**CITY OF KIRKLAND**  
**Planning and Building Department**  
**123 Fifth Avenue, Kirkland, WA 98033**  
**425.587-3600 - [www.kirklandwa.gov](http://www.kirklandwa.gov)**

**To:** Design Review Board  
**From:** Tony Leavitt, Associate Planner  
**Date:** January 25, 2018  
**File No.:** DRV17-00773  
**Subject:** 312 CENTRAL WAY  
CONCEPTUAL DESIGN CONFERENCE

Massing Option 3 | Preferred

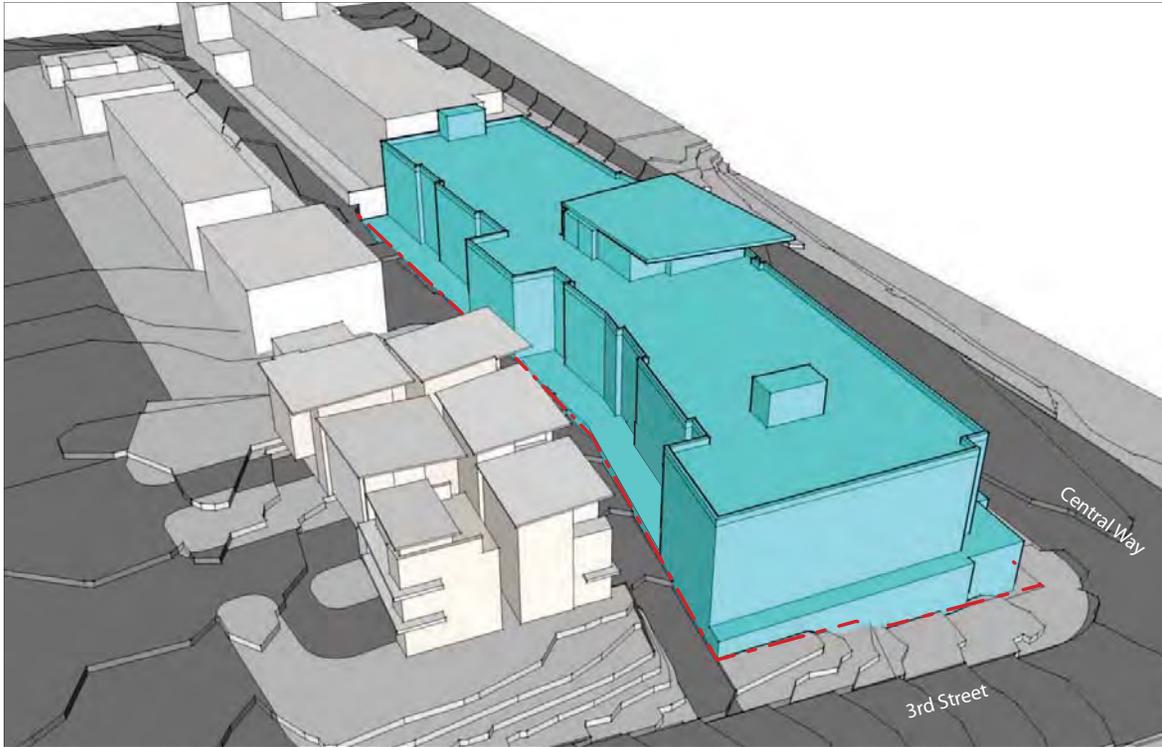
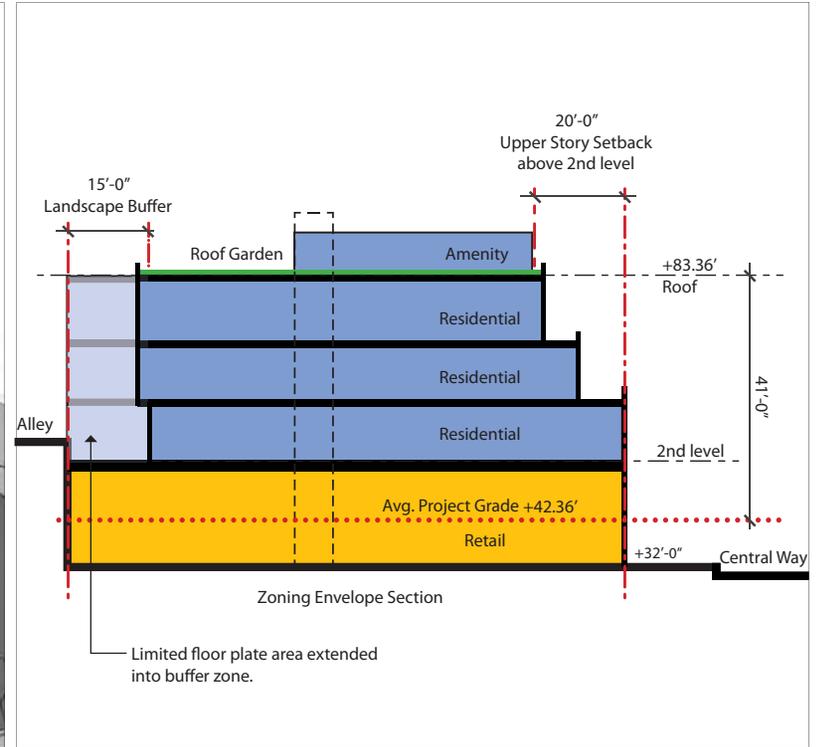
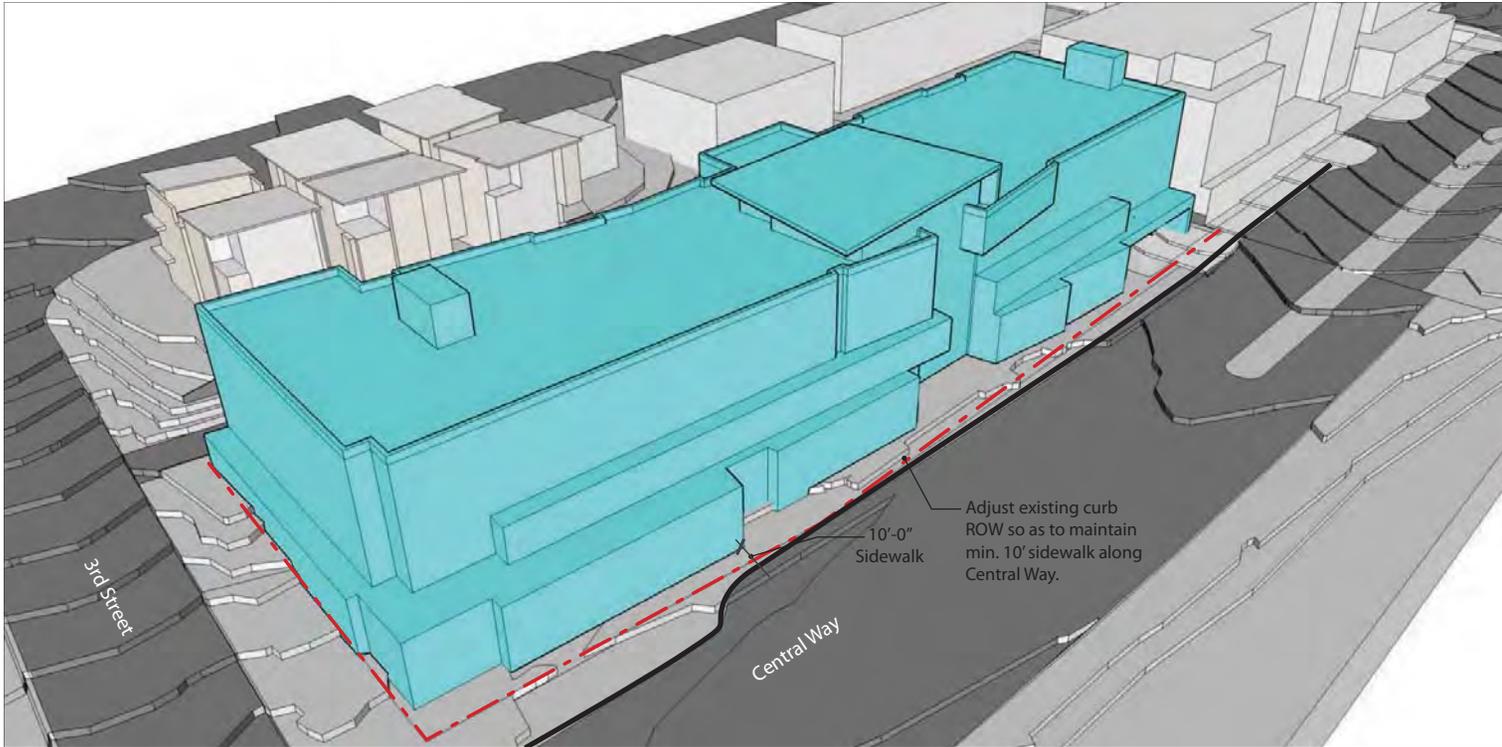
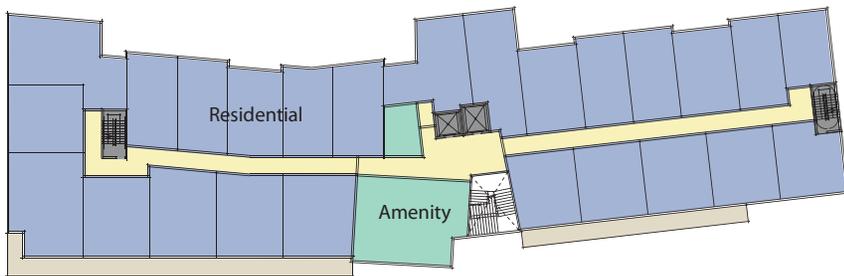
*Staff Comment: The applicant's preferred concept would require an upper story setback reduction from Central Way for the upper stories.*

*As part of the Design Response Conference, the applicant should specify if a minor variation to the required setback yards is being requested. If so, the applicant should provide an analysis that addresses the criteria listed above.*

*Staff Comment: Staff will need to review the project for compliance with the City's height regulations during the Design Response phase. The applicant's preferred concept does show rooftop elements that exceed the maximum height limit. As a result, the applicant will need to apply for a rooftop appurtenance modification*

*Staff's initial review of the proposed rooftop amenity concludes that it does not meet the definition of a rooftop appurtenance, but Staff will review this more prior to the submittal of the Design Response Conference application.*

*The applicant's preferred concept would require a landscape buffer modification pursuant to KZC Section 95.46.1. The modification requires agreement from neighboring property owners and approval by Staff.*

1. What are the key vantages of the project?
2. Identify appropriate mitigation techniques for building massing of the proposed buildings. Possible techniques include vertical and horizontal modulation, corner treatment, and roof forms. The applicant has provided building layout and massing designs including a preferred option for the **DRB's review and comment** (see Attachment 2).
3. **Provide feedback on proposed minor variations as part of applicant's preferred massing option.**
